RE: Responses to February 23, 2024 NYSDOH and March 8, 2024 NYSDEC Comments on the SVI Investigation Work Plan (GHD, January 24, 2024)

Re: Soil Vapor Intrusion Investigation Report
General Instrument Corporation Site, Sherburne
Chenango County, Site No.: 709010

**Revised SVI Investigation Work Plan
(GHD, March 18, 2024)**

**Former General Instrument Corporation
Site (#709010), Sherburne, New York**

FIGURE 2

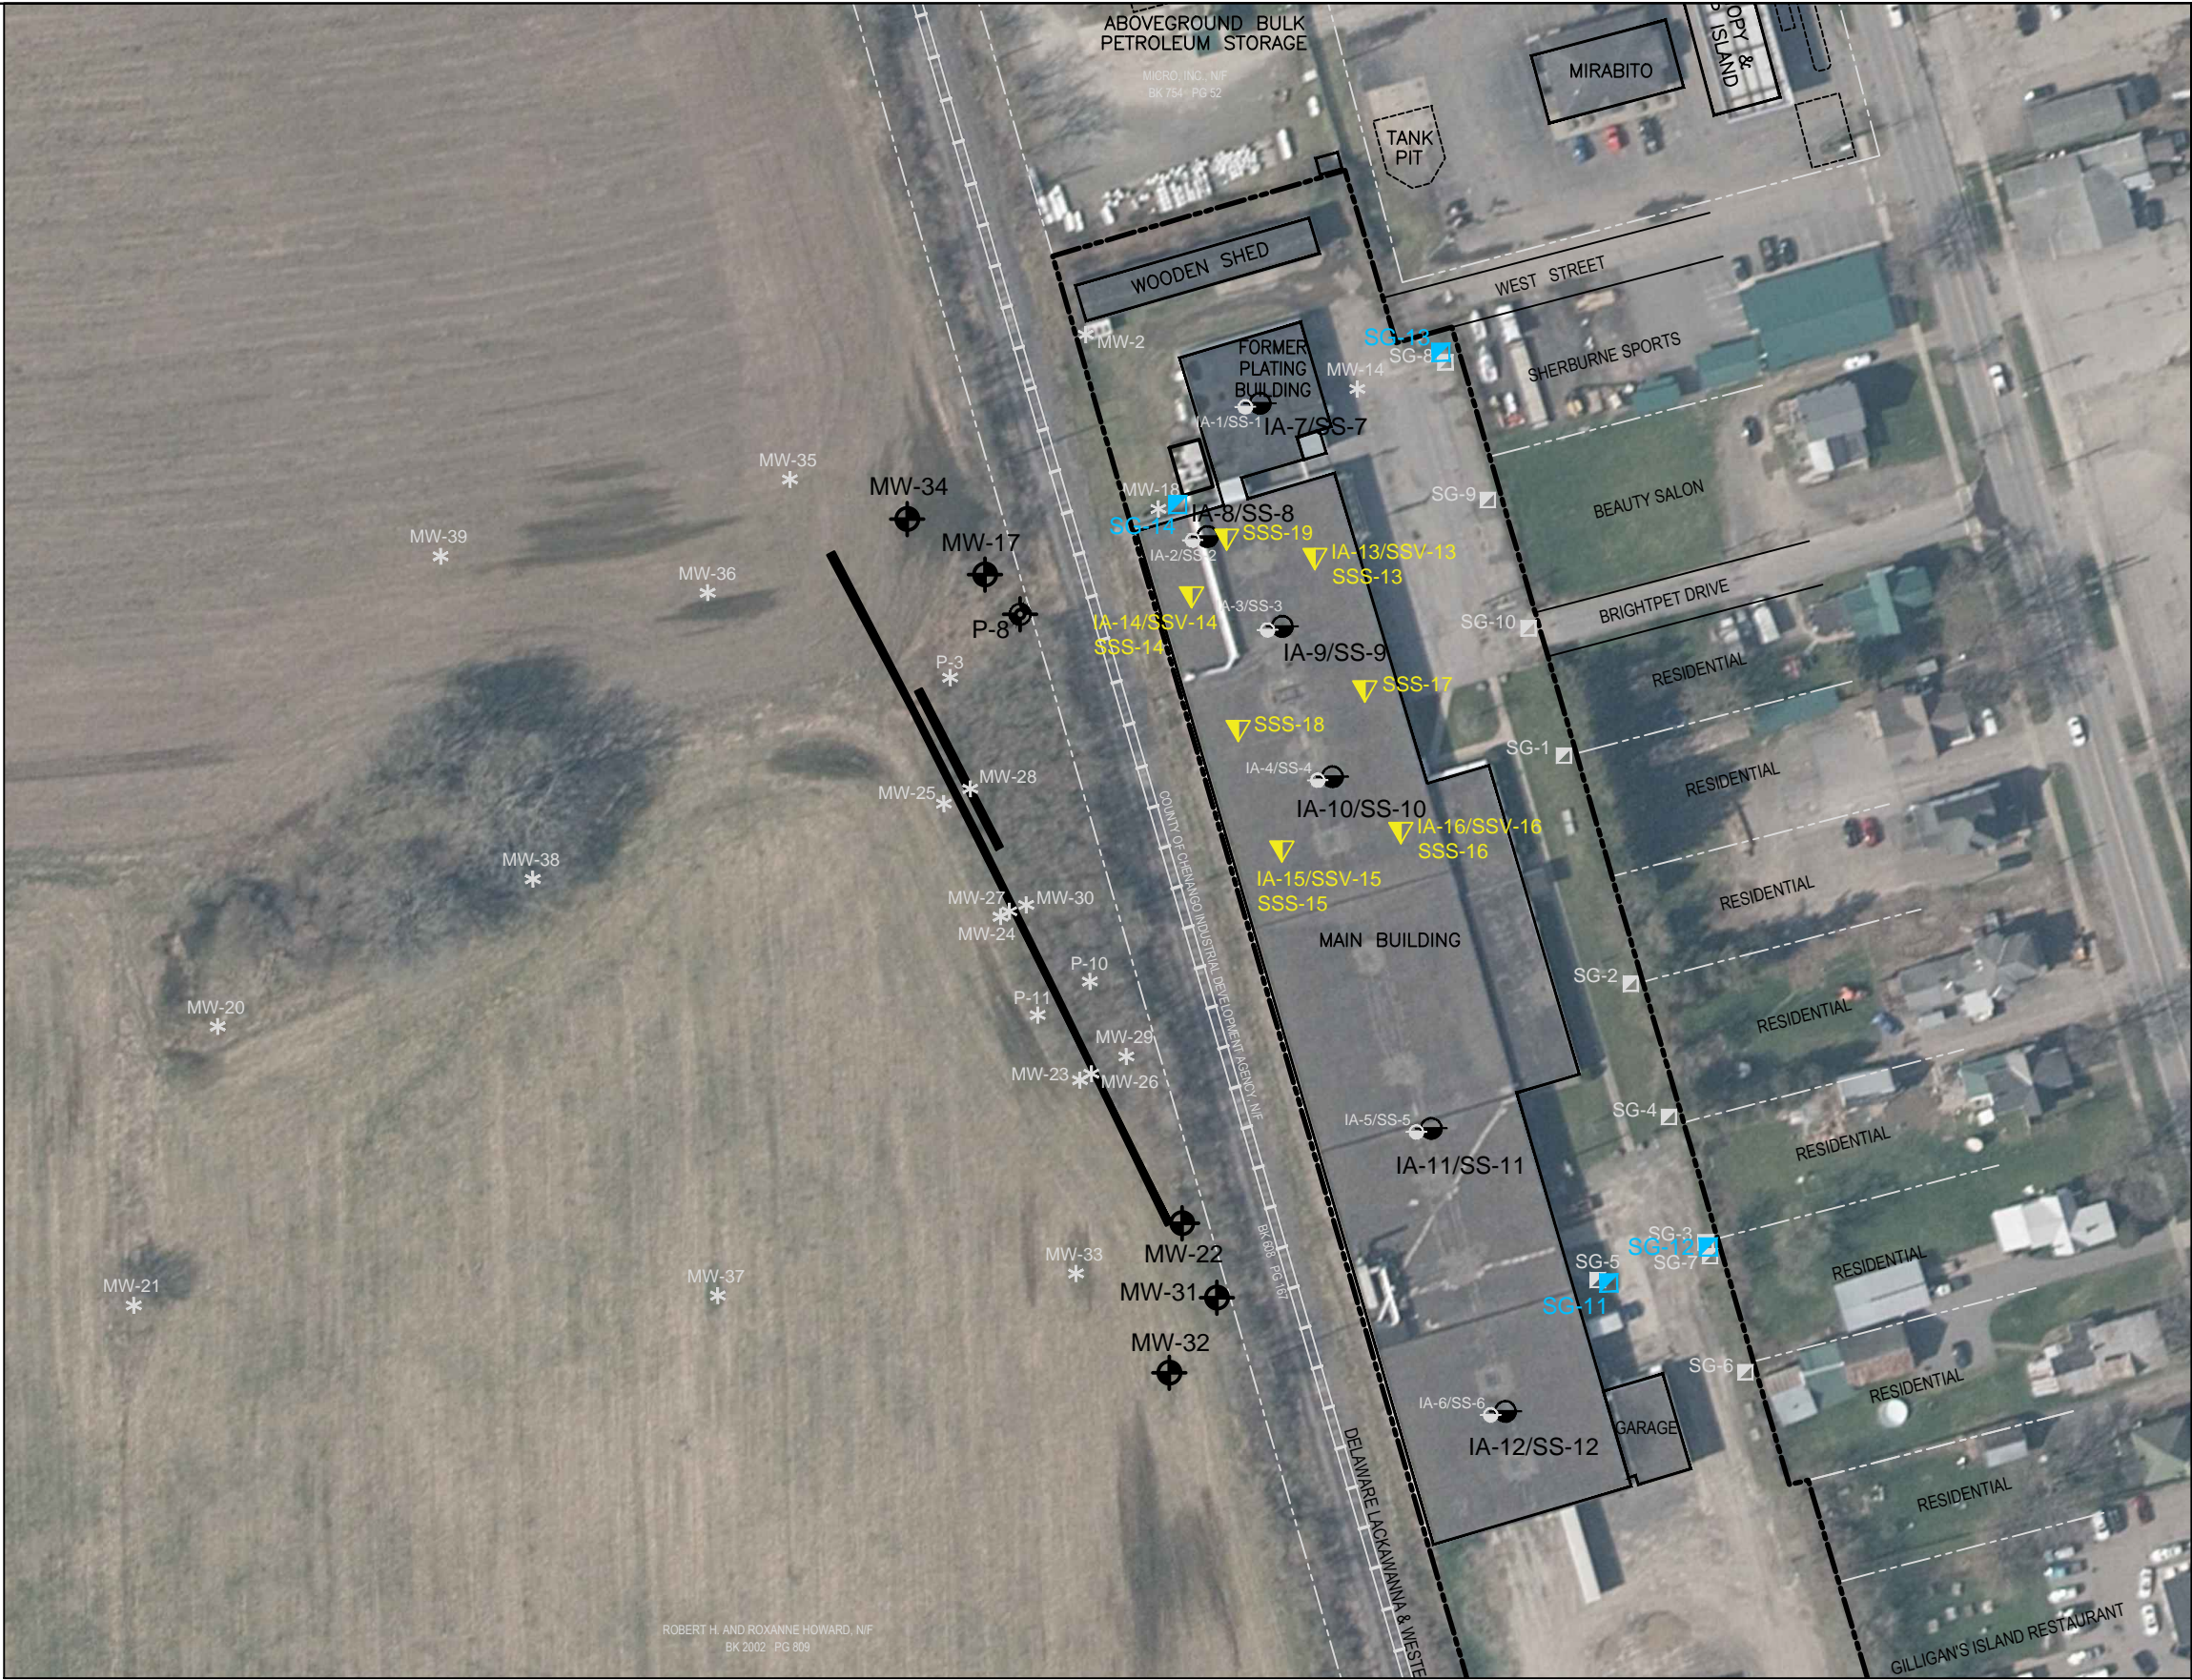
- b. *Section 2.4, Summary of Previous SVI Investigations – Please identify on a figure the current configuration/uses of the site building, with particular emphasis on the northern building area where elevated concentrations of trichloroethene (i.e., 8,000 µg/m³) were previously identified.*

GHD Response No. 2b: The building is currently utilized for warehouse operations associated with a pet supply company, with pallets of pet food and other various items stored throughout the building. Workers navigate the building with fork trucks throughout the day pulling product to load delivery trucks. The former plating building portion of the building is generally vacant and used for storage with occasional access for a short duration of time. Information was added to Section 2.1 of the revised *SVI Investigation Work Plan* to clarify historical and current uses of the building.
